TEXAS COMMISSION ON ENVIRONMENTAL QUALITY

NAME OF PROJECT: **Oakwood Estates Unit 19**; Located at dead-end of Acorn Drive; New Braunfels, Texas

TYPE OF PLAN: **Request for Approval of an Organized Sewage Collection System (SCS) Plan**; 30 Texas Administrative Code (TAC) Chapter 213 Edwards Aquifer

Edwards Aquifer Protection Program ID No. 3089.00; Investigation No. 1041752; Regulated Entity No. RN106535529

SHEET
13
OF 20

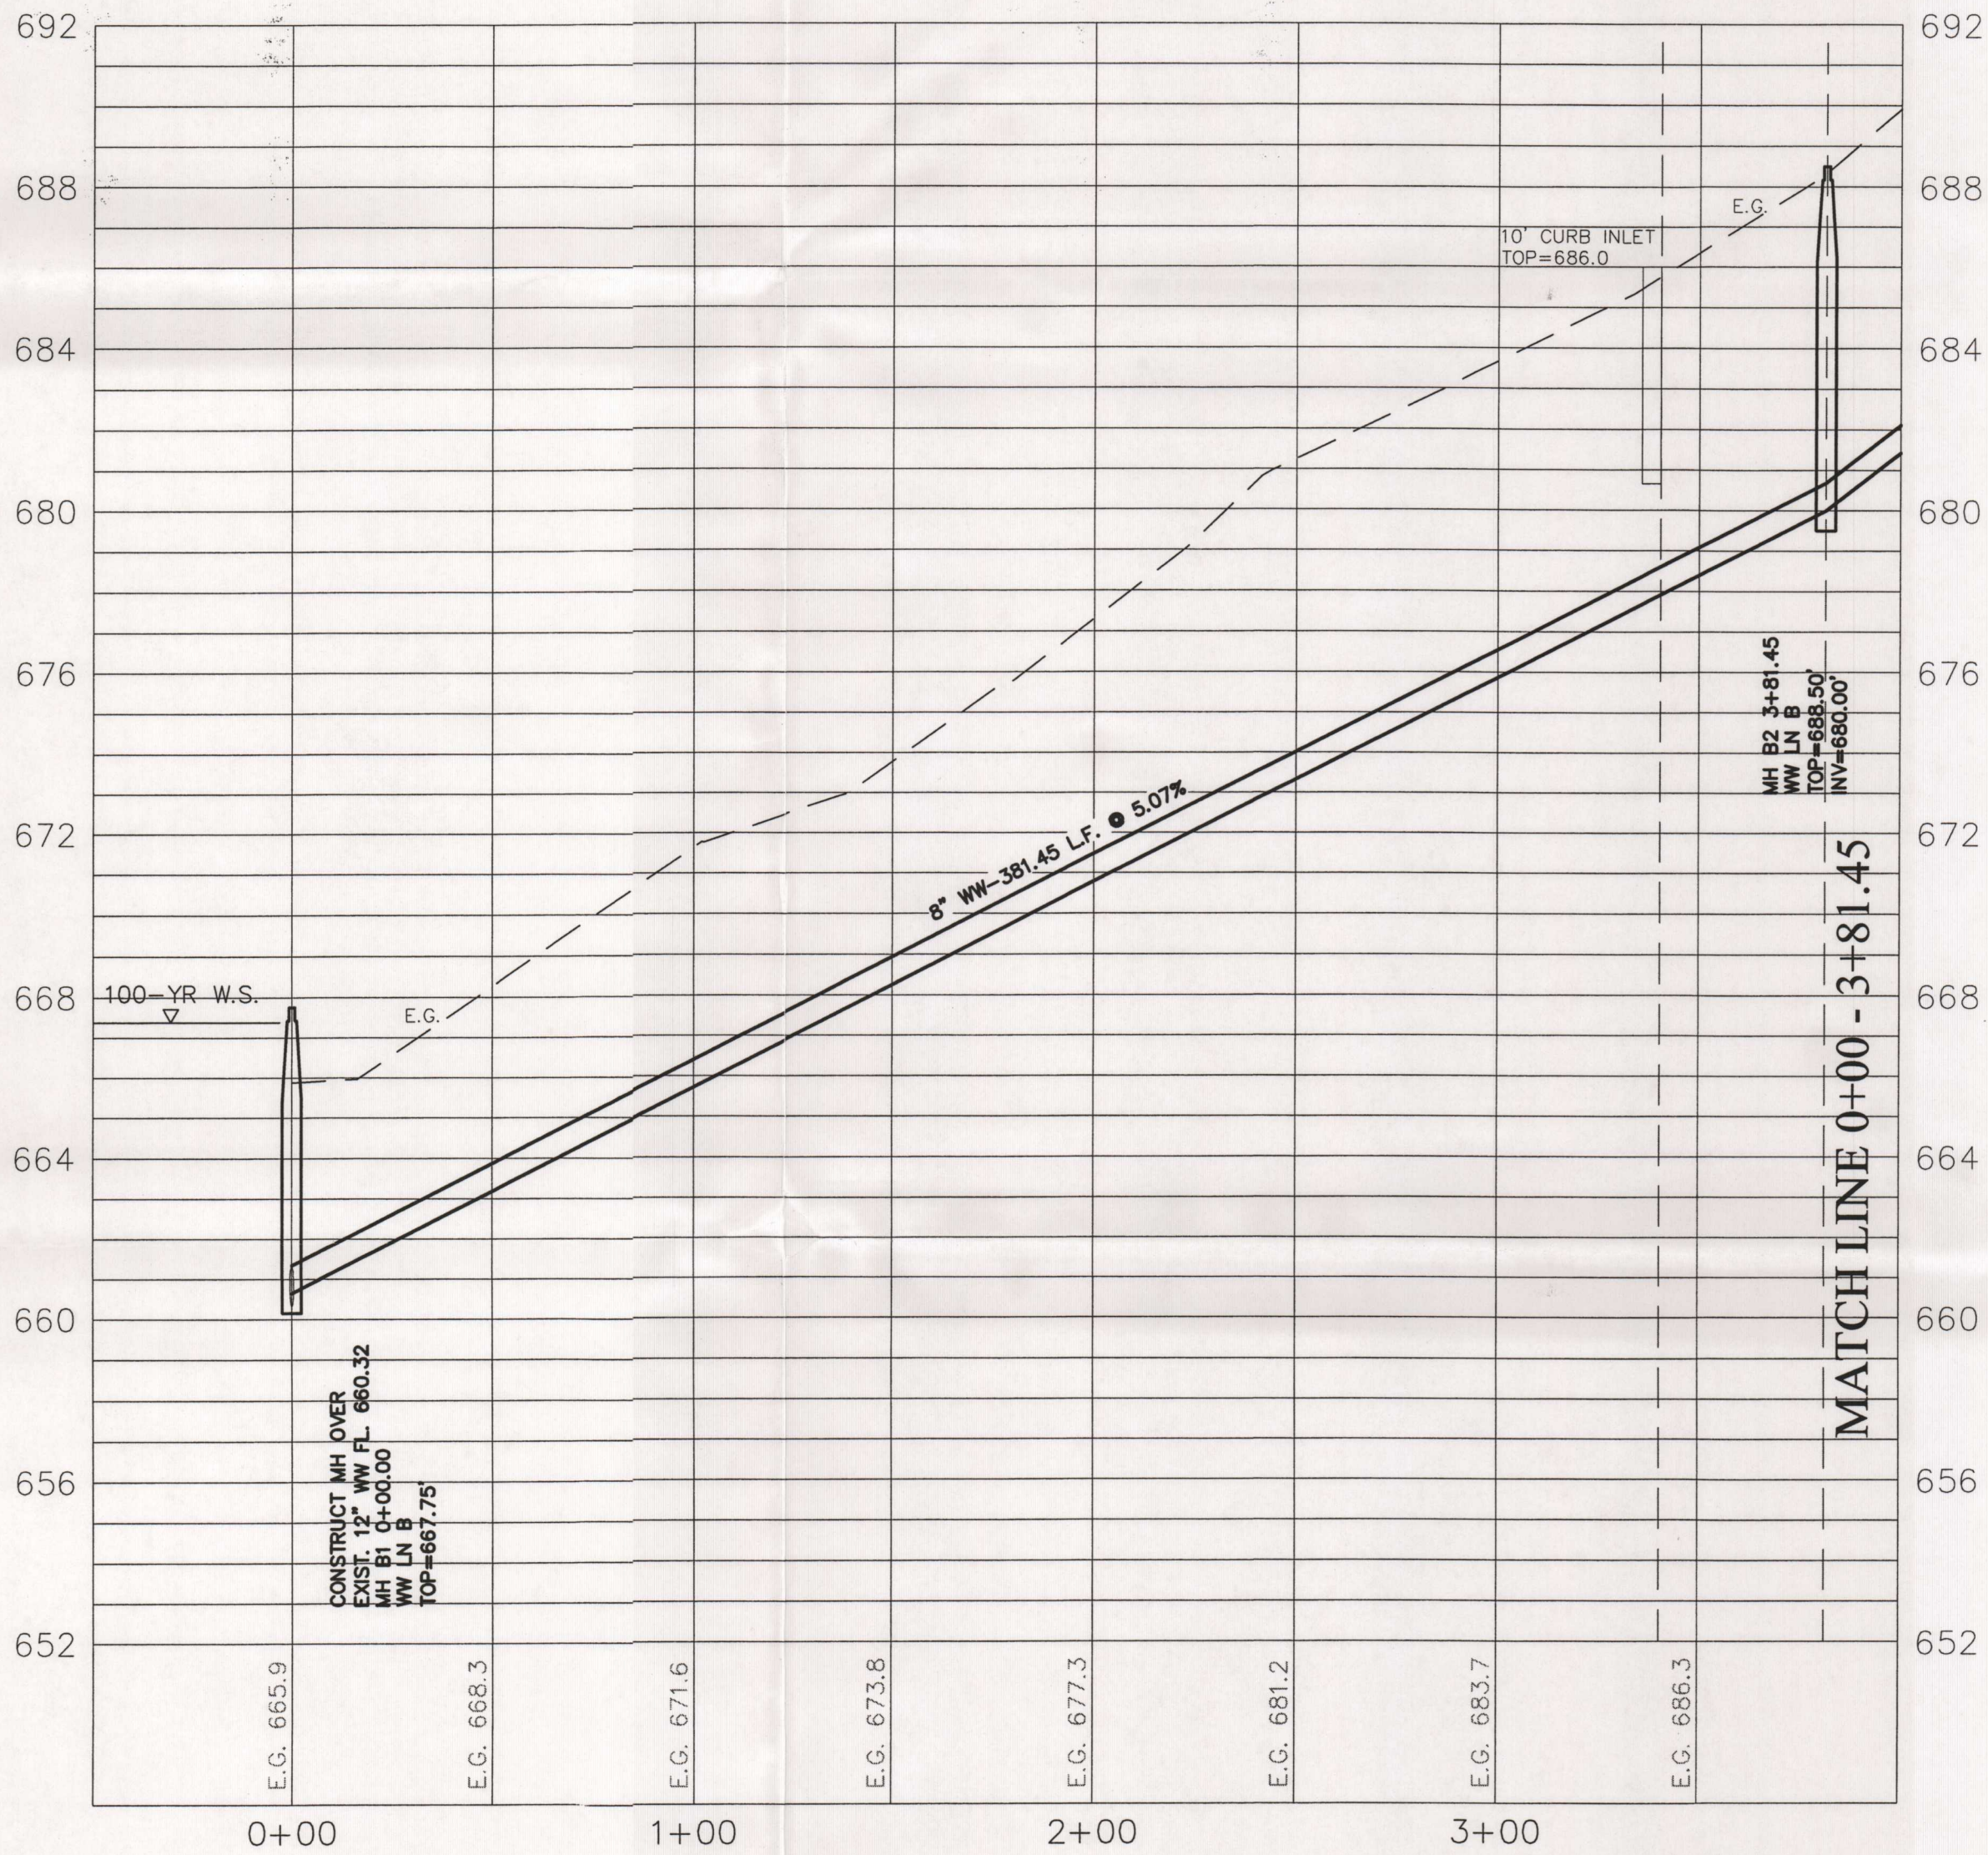
C ASTM D-2241 pipe must be shown on plan and profile sheets. Please review and revise accordingly.

C Please review item 24 in the SCS application and confirm water line crossings within 9 feet of sewer lines. Note also that these crossings should be indicated on all plan and profile sheets.

R The pipe has been specified on the plan and profile sheet.

R These crossings have been updated in the application and confirmed on the plan and profile sheets.
